No.PR22-GNE-0127-ETS RevisionB

TECHNICAL INFORMATION

Title : Abnormal noise or no feeding when feeding from upper tray (Shaft breaks at upper tray driving gear)

Photo from left back of Frame base	Photo from Front side
NG	 This axis is tilted.	 Upper tray driving gear Not connected normally
OK		 Connected correctly

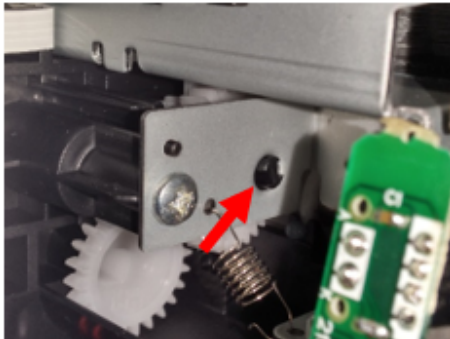
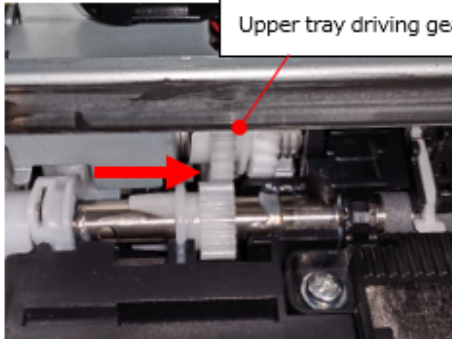
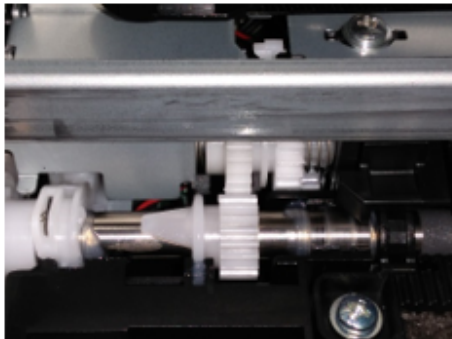
Shaft of gear that drives the upper tray was broken.
 As the result, the meshing of the gears became abnormal, and drive was not transmitted.
 So, occur abnormal noise or the upper tray did not operate, and a paperless error occurred.

-It is estimated that the R of the shaft base is not suitable, and it is due to insufficient strength.

Adding R of the axis on the left side of the frame base by modifying the mold.
